A19 Downhill Lane Junction Improvement

Scheme Number: TR010024

**7.18 Written Submission of Applicant's case
put orally at Issue Specific Hearing 2 on 16th
October 2019**

WRITTEN SUBMISSION OF APPLICANT'S CASE PUT ORALLY AT ISSUE SPECIFIC HEARING 2 ON 16TH OCTOBER 2019

REVISED VERSION OF FIGURE 6.1 OF THE ES

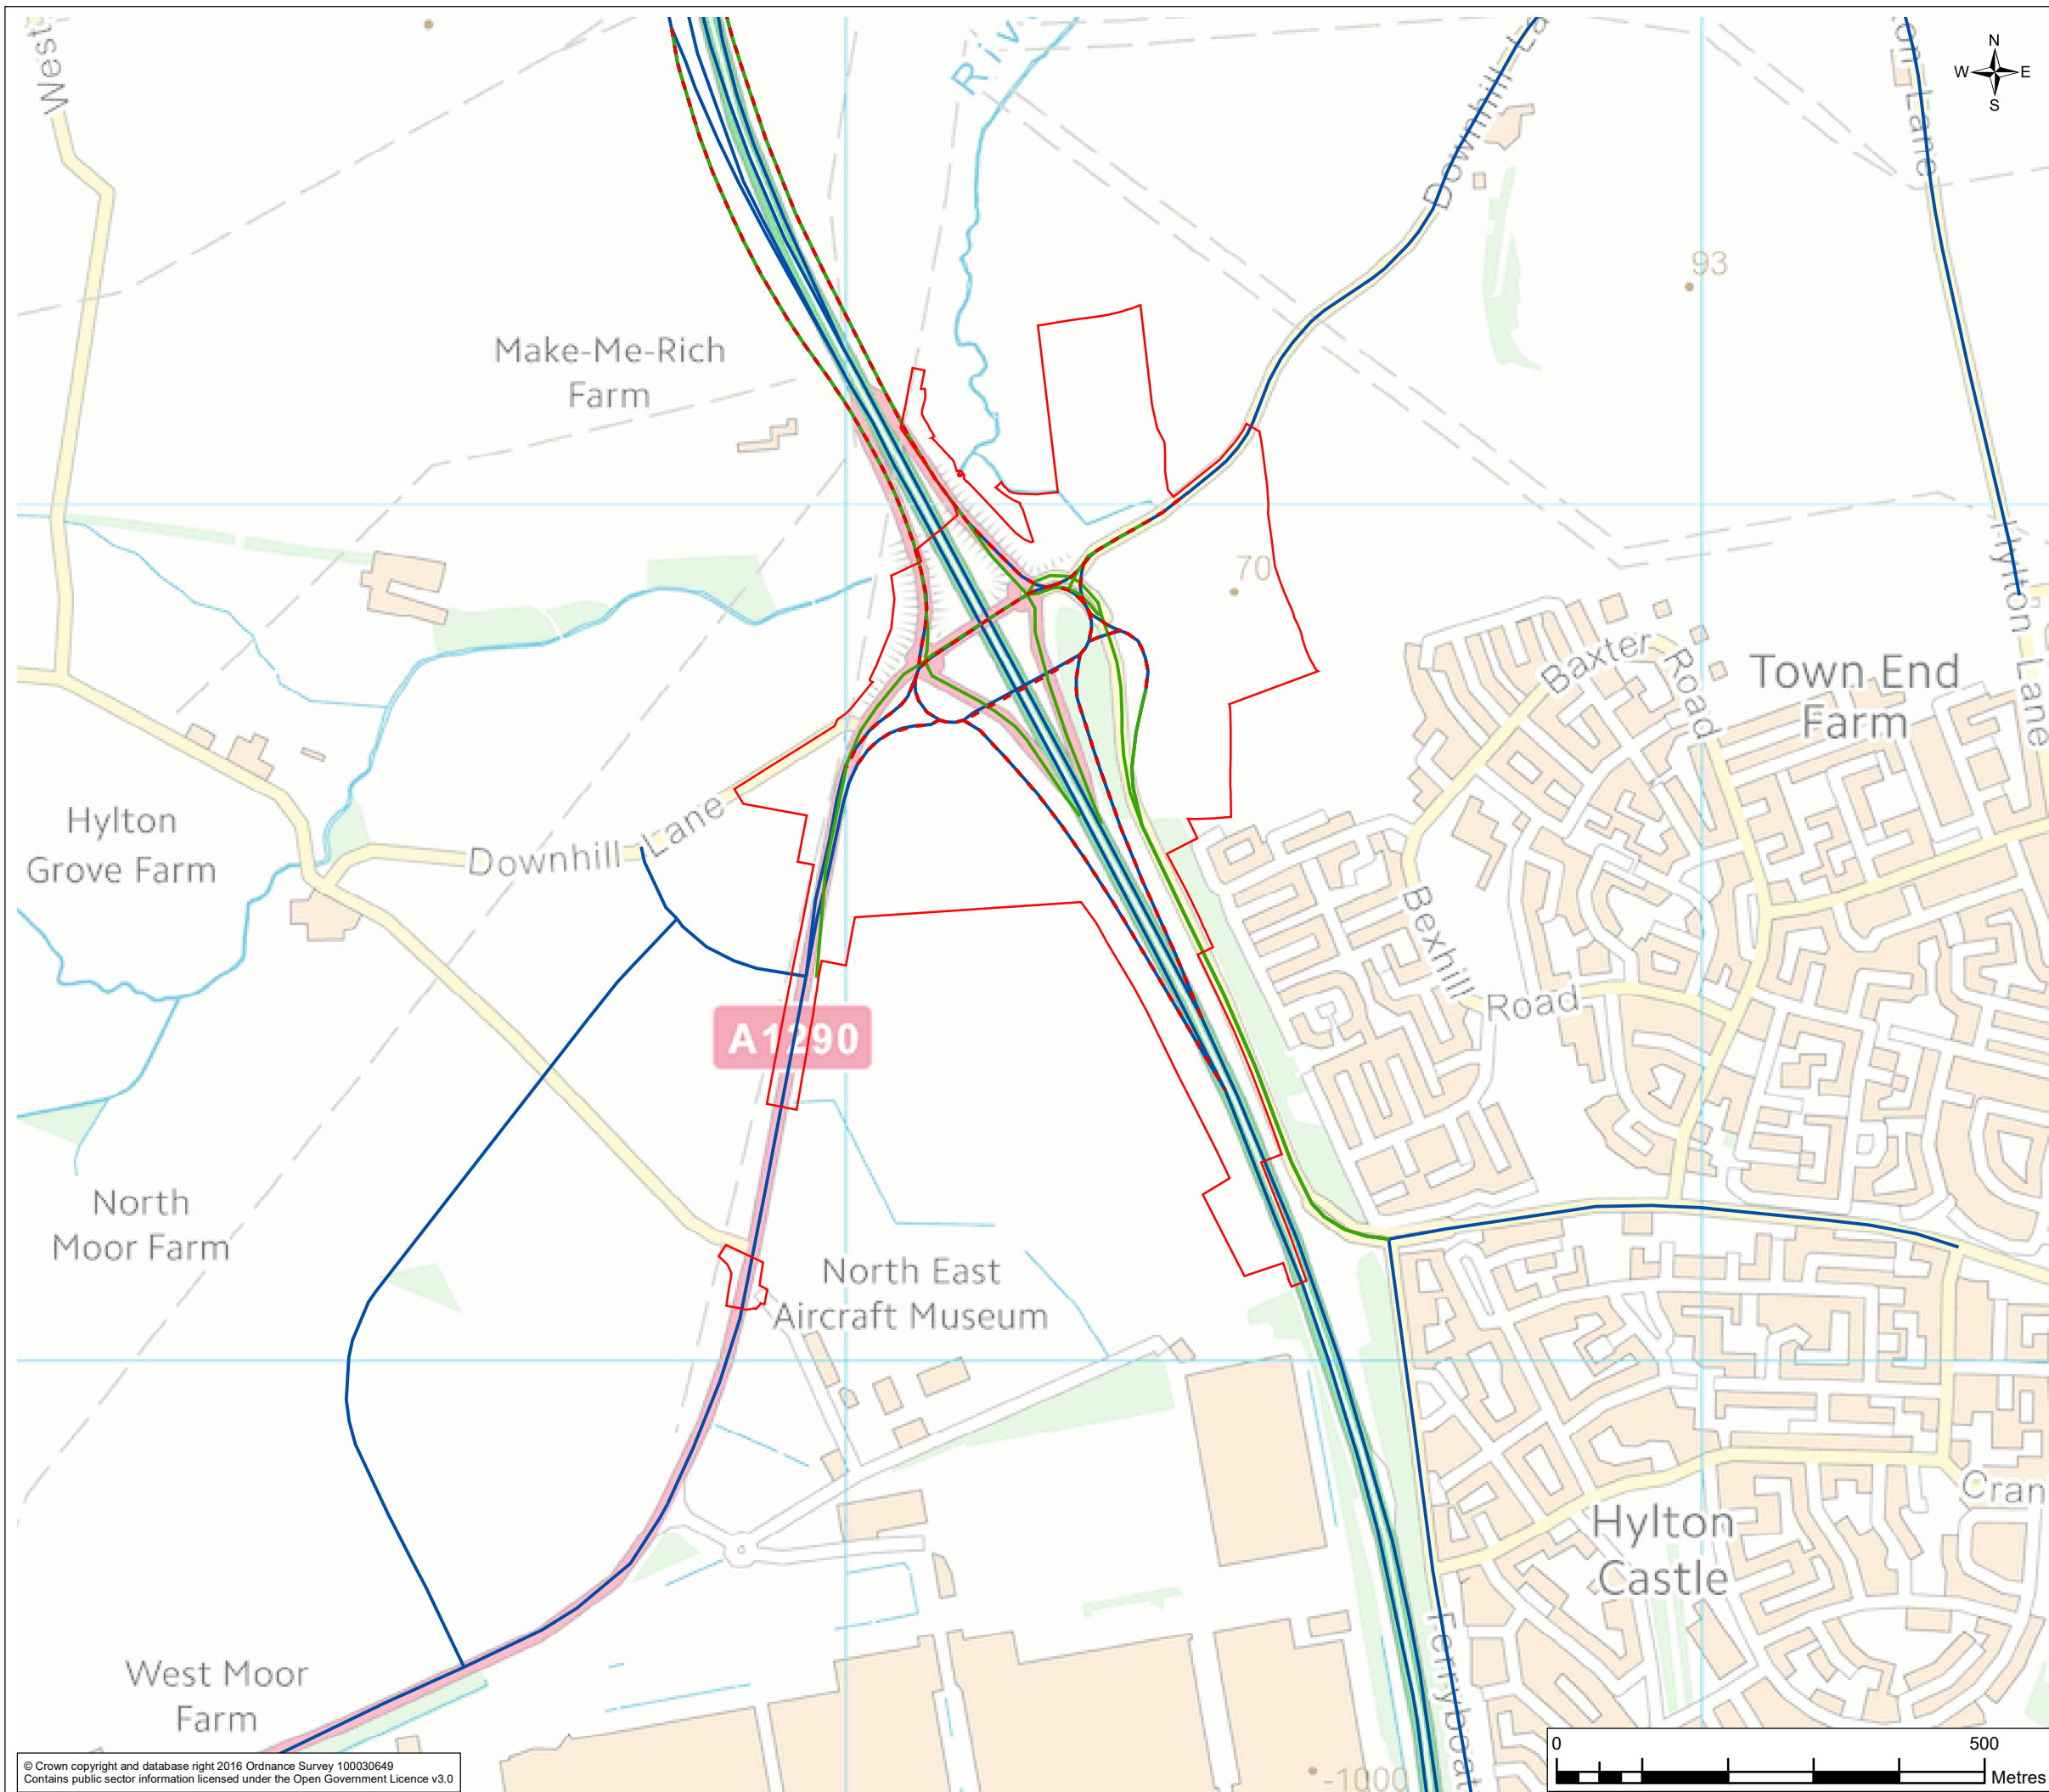
- 5.2 At figure 6.1 of the ES and the Applicant's Response to the ExA's written question 1.2.1 [TR010024/APP/7.13], MR clarified to the ExA that the red and green colours reflecting the road networks are within the yellow area. MR said he would provide a plan with greater detail.

[Post hearing note: the more detailed version of the plan is included as Appendix 2 to this document]
